UNITED STATES
NUCLEAR REGULATORY COMMISSION
WASHINGTON, D. C. 20555

SUBJECT: ALWR DESIGN BASIS TORNADO

SAFETY EVALUATION BY THE OFFICE OF NUCLEAR REACTOR REGULATION
OF RECOMMENDED MODIFICATION TO THE
R.G. 1.76 TORNADO DESIGN BASIS FOR THE ALWR

FIGURE 1 Wind Speeds (mph) with a 10^{-7} Probability of Occurrence Estimated from the Upper End of the 90% Strike Probability Confidence Interval (Fig. 30 from NUREG/CR4461)

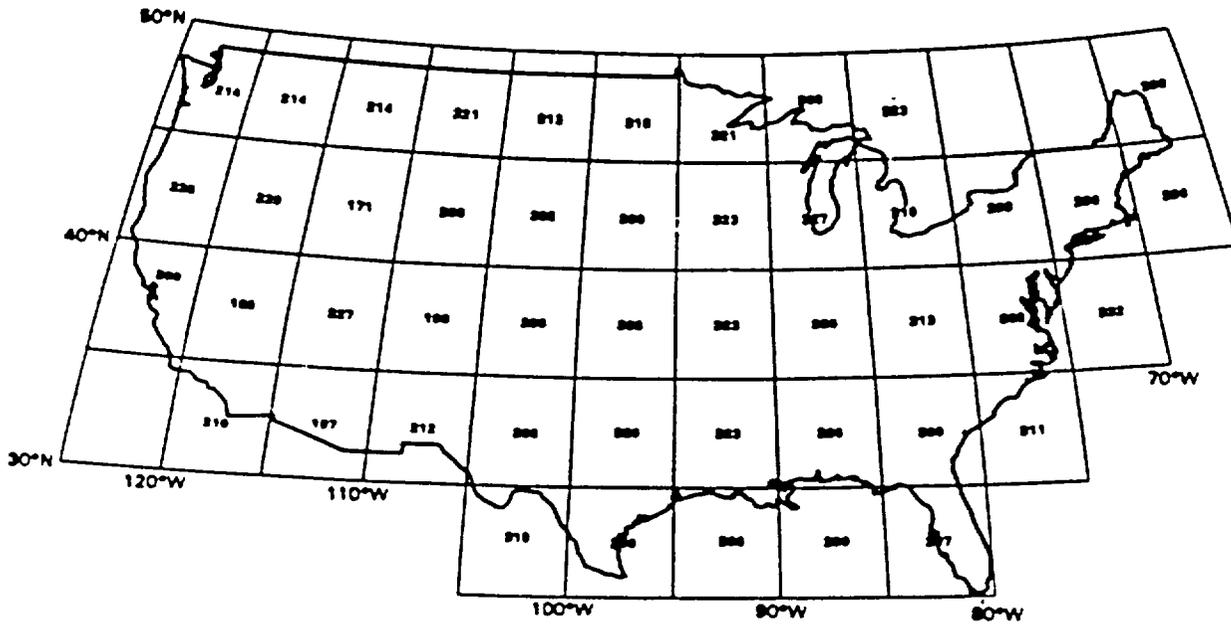
Using the revised methodology, the tornado strike probabilities range from near 10^{-7} yr⁻¹ for much of the western United States to about 10^{-5} yr⁻¹ in the central United States. The 10^{-7} yr⁻¹ wind speeds estimated using local strike probabilities and regional intensity probability distributions range from less than 153 mph to 332 mph. These wind speed estimates are 50 to 100 mph lower than the speed estimates presented in WASH-1300 and Regulatory Guide 1.76 for most of the United States. On the basis of this analysis, it would appear to be reasonable to reduce tornado design basis wind speeds to 200 mph for the United States west of the Rocky Mountains and to 300 mph for the United States east of the Rocky Mountains."

The staff has reviewed the contractor's study and found agreement with the proposed revisions to the WASH-1300 methodology but believes that, in order to take into account uncertainties in the data base and analyses, the upper 90% strike probability confidence level should be utilized for estimating the probability of tornado occurrence. In keeping with the R.G. 1.76 regulatory position which allows for lessening of the DBT based upon a comprehensive analysis to justify less conservative DBT parameters, the staff concluded that the 10^{-7} /yr probability of occurrence at the upper 90% confidence level from the contractor report may be utilized as the DBT. Fig. 1, which is identical to Figure 30 in NUREG/CR-4461, shows the associated wind speed by 5-degree latitude/longitude sectors throughout the United States. These sectors may be assigned to four regions (see Figure 2), which can be characterized by the following DBT parameters:

Figure 2 Maximum Wind Speed is indicated for each of 4 regions of the United States. The circled area illustrates boundaries where a lower wind speed can be selected if justified.

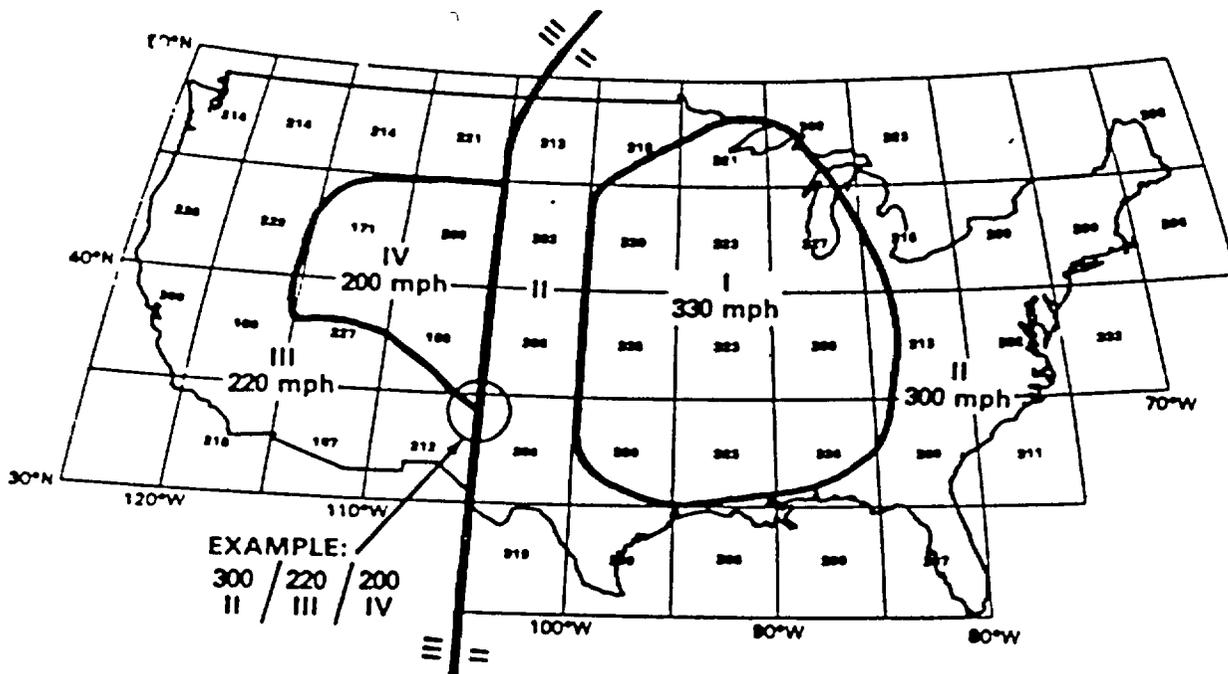
^a When a plant site falls near, or on, boundary lines separating two or three velocity zones, either (1) the higher of the two or three regional wind velocities should be used or, (2) the lower of the two or three wind velocities may be used with appropriate justification (see Figure 2 for example).

Based on its review described above, the staff concludes that the tornado design criteria in Table II and Figure 2 are acceptable on an interim basis for ALWRs until such time as R.G. 1.76 is revised.

<u>Region</u>	<u>Maximum Wind Speed (mph)^a</u>	<u>Rotational Speed (mph)</u>	<u>Maximum Translational Speed (mph)</u>	<u>Radius of Maximum Rotational Speed (feet)</u>	<u>Pressure Drop (psi)</u>	<u>Rate of Pressure Drop (psi/sec)</u>
I	330	260	70	150	2.4	1.7
II	300	240	60	150	2.0	1.2
III	220	170	50	150	1.0	0.5
IV	200	160	40	150	0.9	0.3
